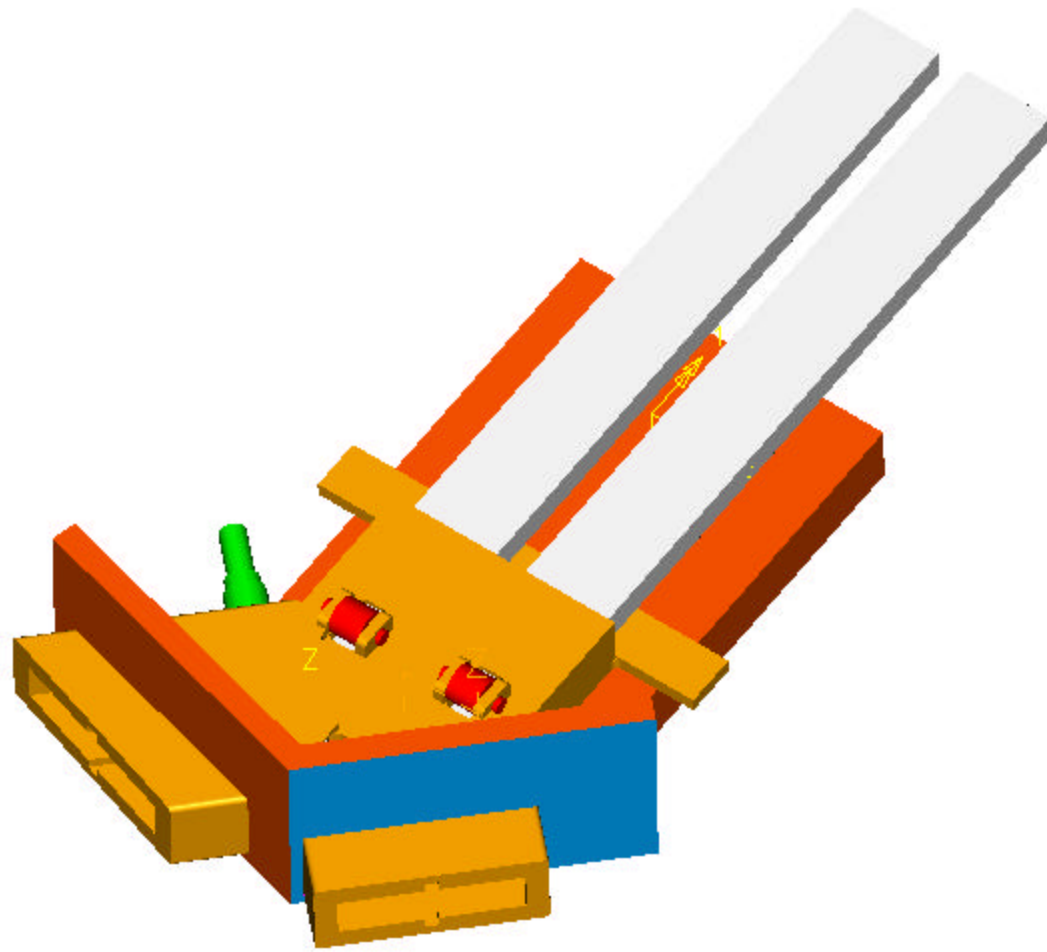
Attachment Points. We (UW) still have not figured out exactly how this will attach to our structure. The minimum is two (4-40) bolts in these locations. The spacing from center to center is 3.500"

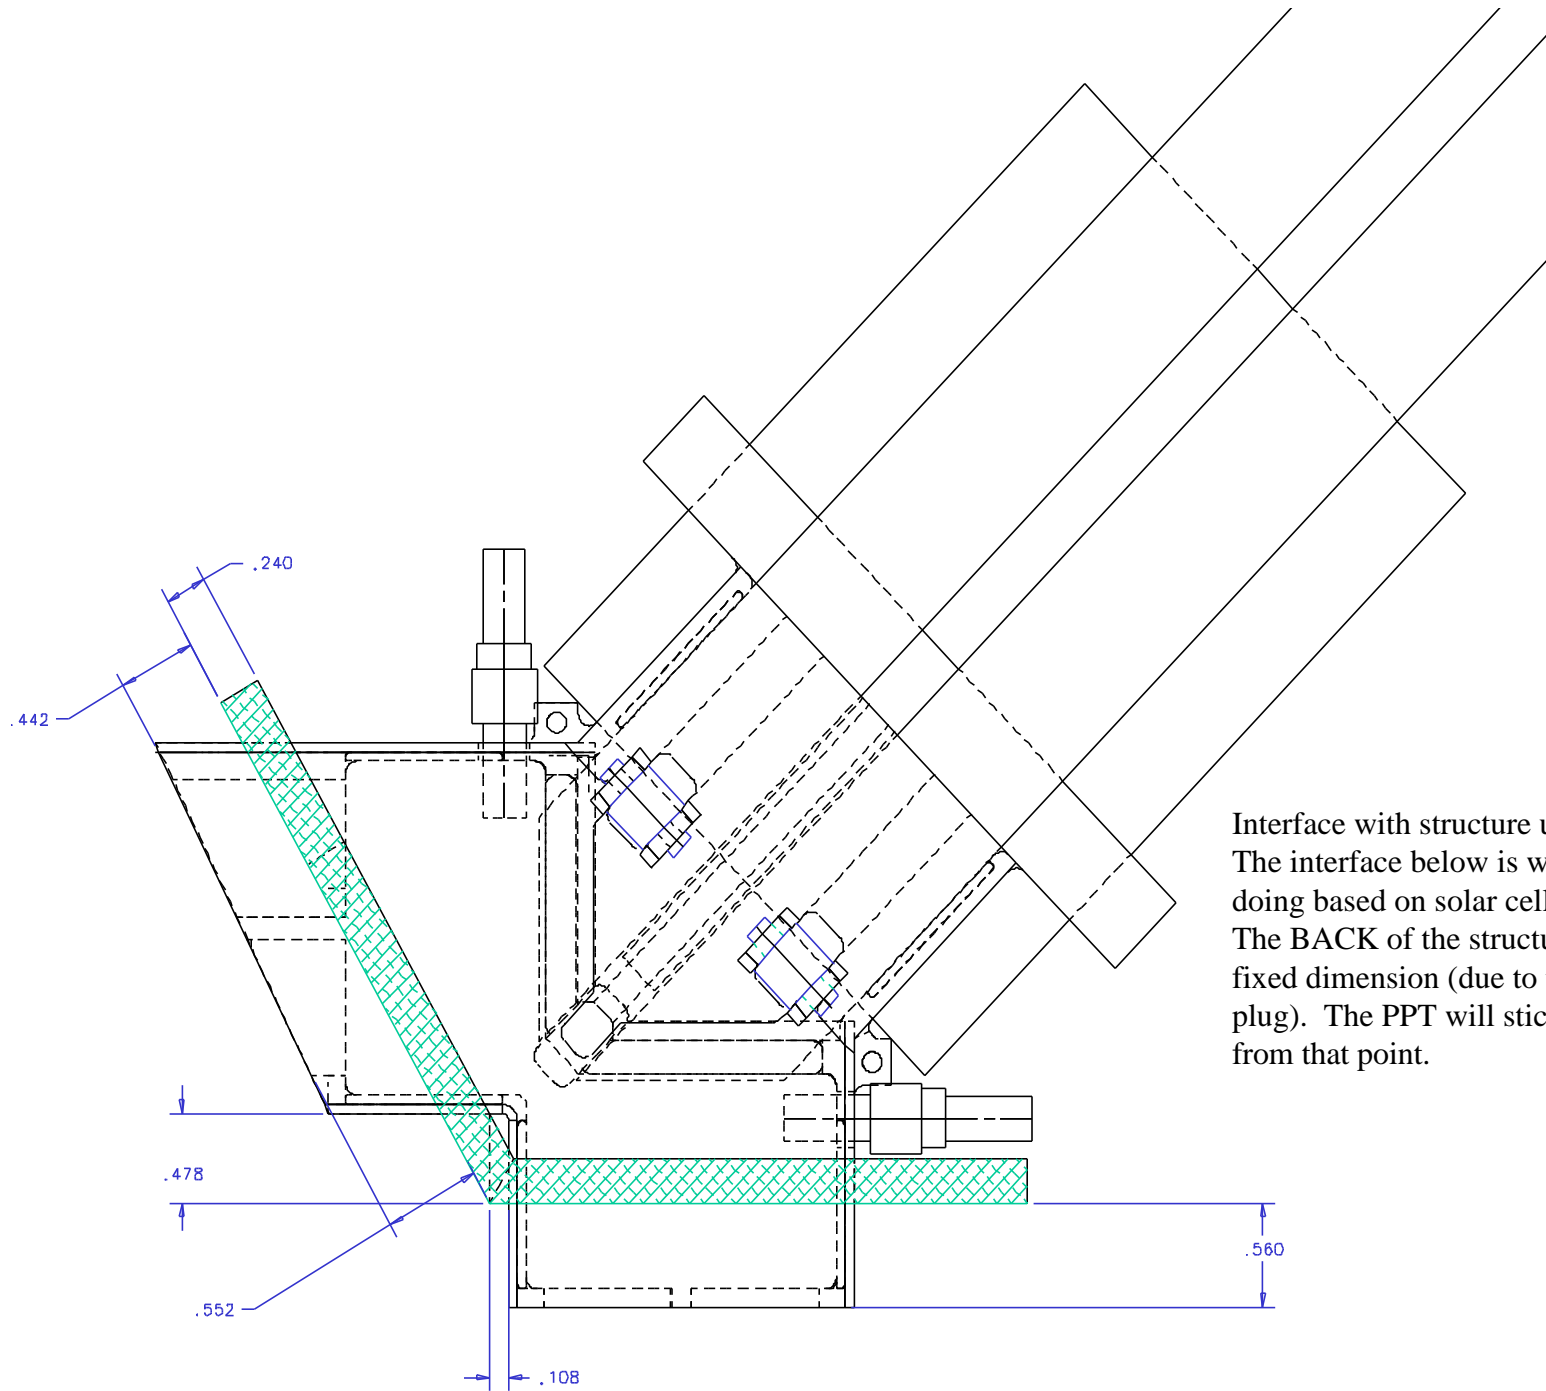
Interface with structure up to you.
The interface below is what UW is
doing based on solar cell layout.
The BACK of the structure is the
fixed dimension (due to the spark
plug). The PPT will stick out 0.80"
from that point.
